### NEW ENTRY ADDITION AT PARKING LEVEL

KML, LLC  
2008K010036  
721 DUNDEE AVE

721 DUNDEE  
BLVD  
CORRECTED  
SITE PLAN  
11/10/10

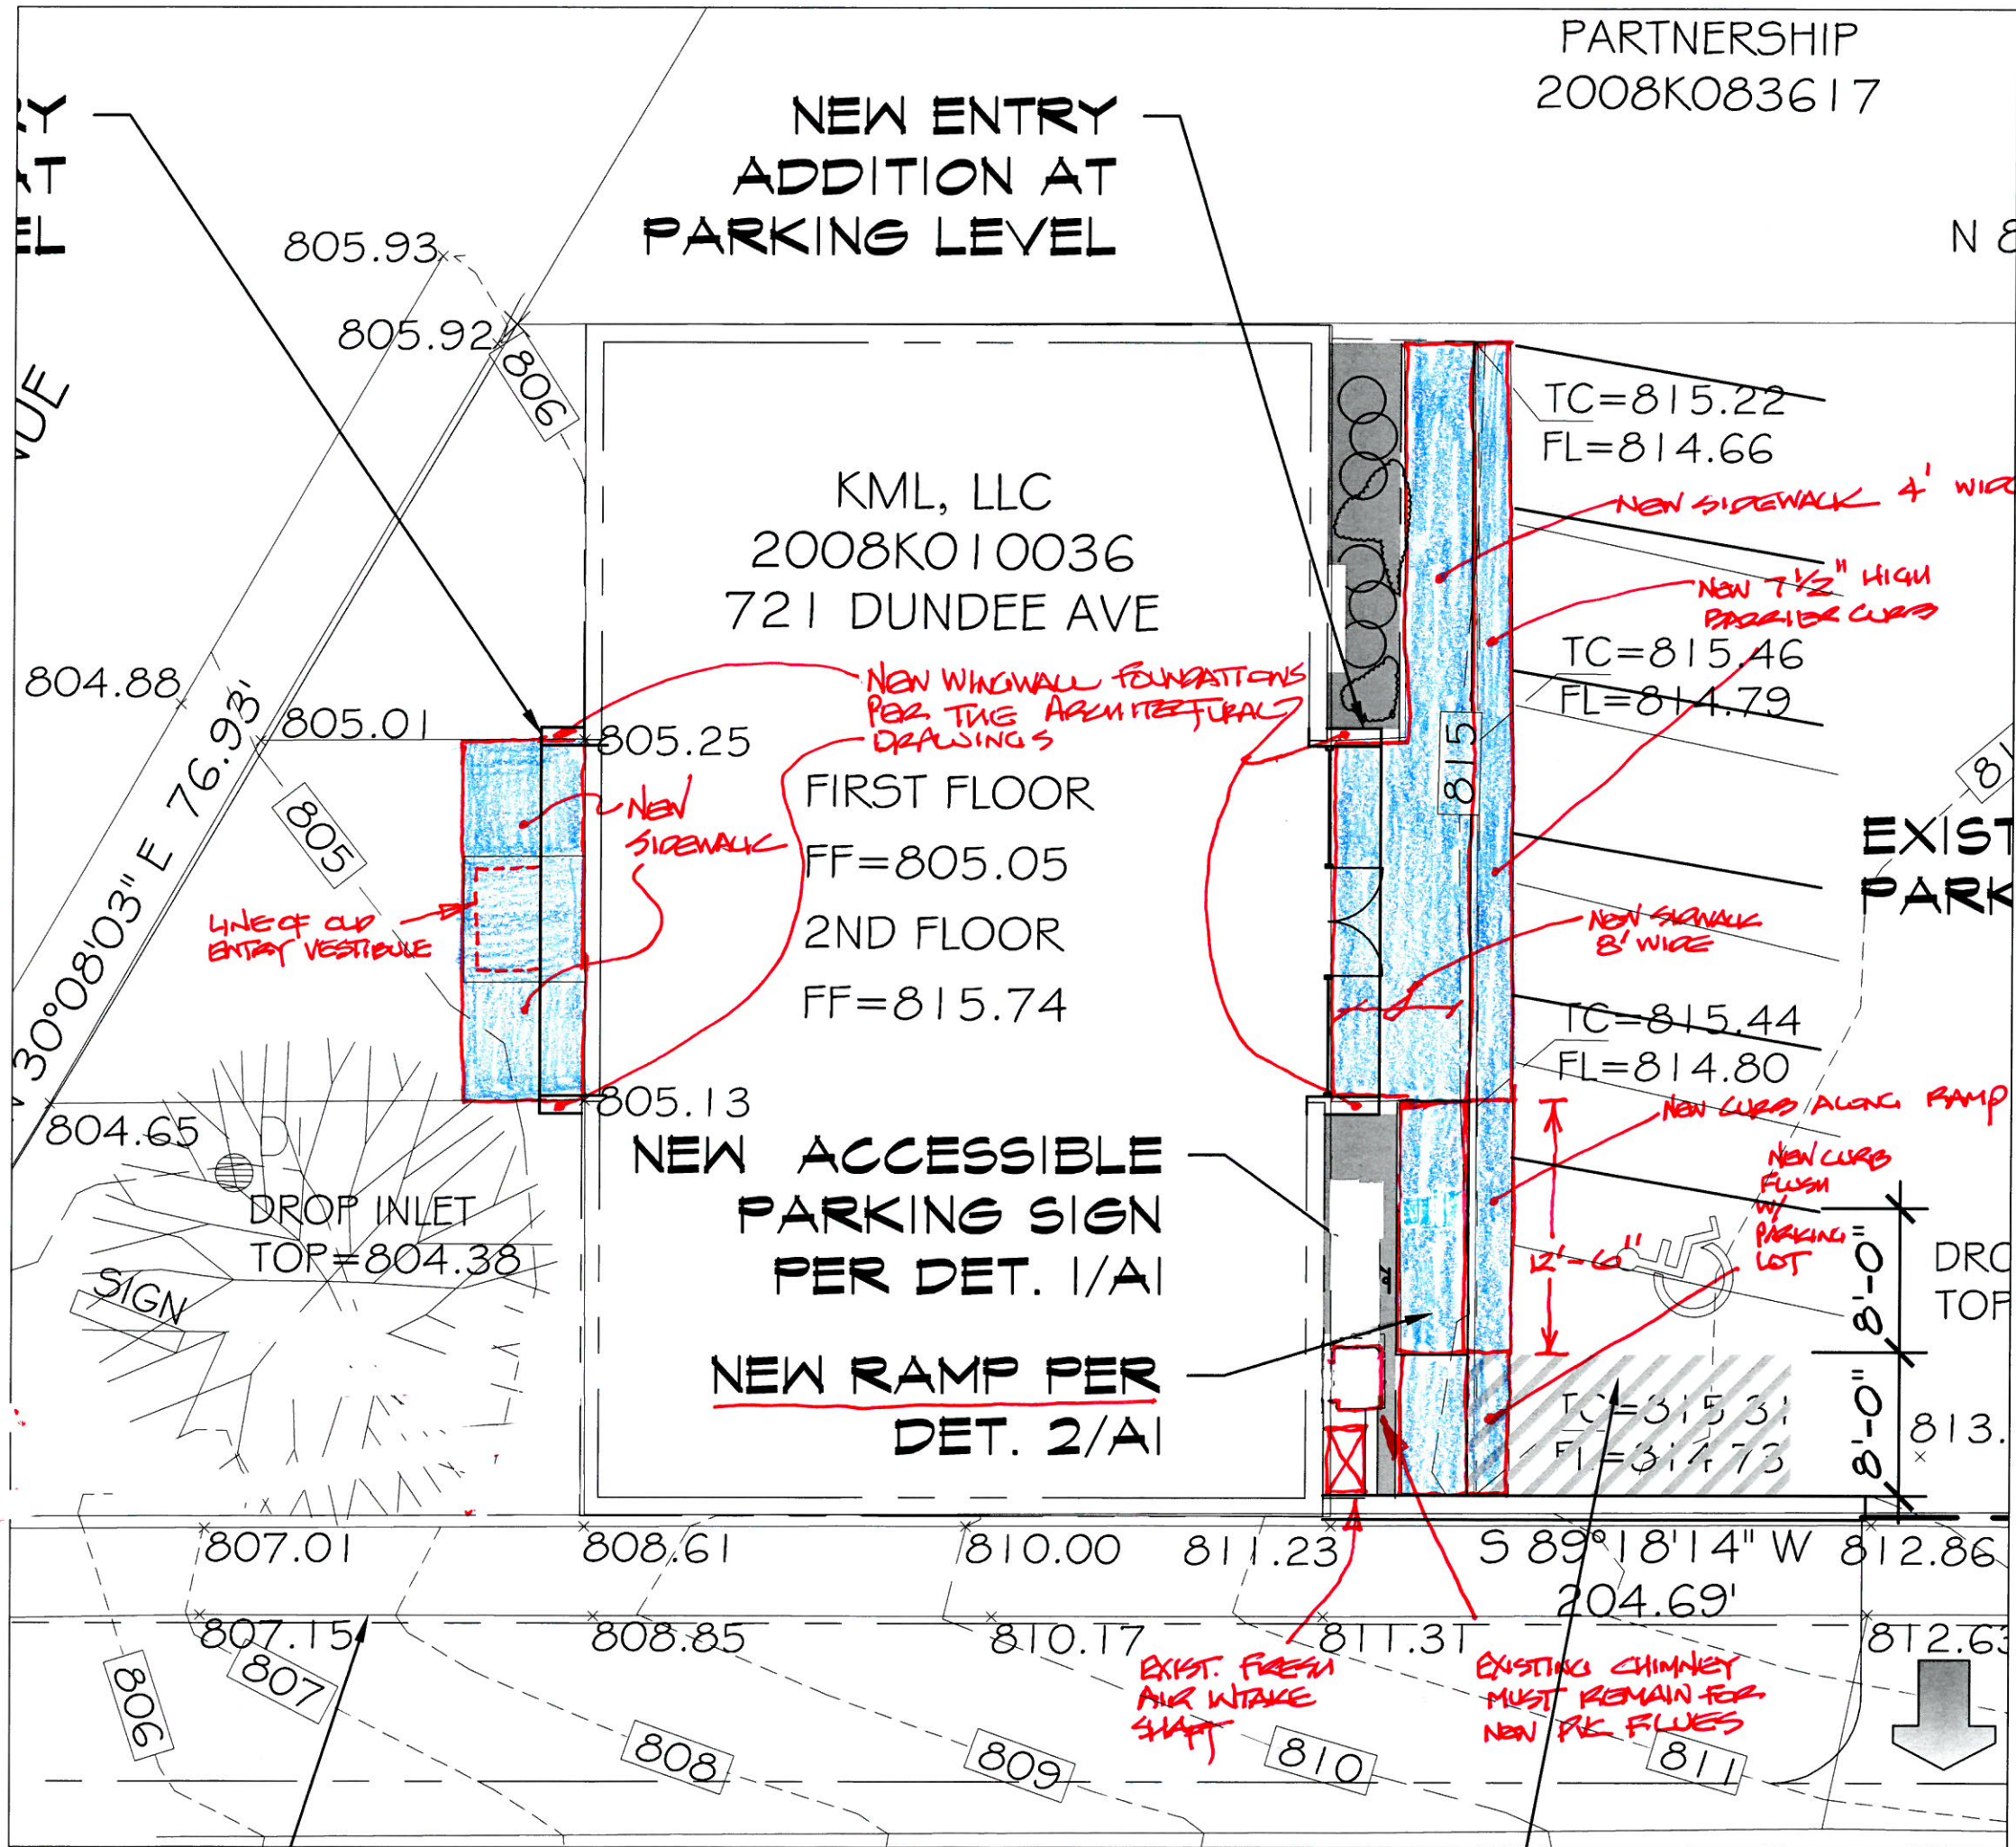
**NEW ACCESSIBLE  
PARKING SIGN  
PER DET. 1/A**  
**NEW RAMP PER  
DET. 2/A**

DEMOLITION  
CONTRACTOR  
TO REMOVE  
ALL SIDEWALK  
ON EAST & WEST  
SIDES  
HIGHLIGHTED  
IN [blue box].  
CONCRETE  
CONTRACTOR TO  
PROVIDE NEW  
SIDEWALK, CURB  
& RAMP IN  
THESE AREAS

EXISTING CHIMNEY  
MUST REMAIN FOR  
NEW AC FLUES
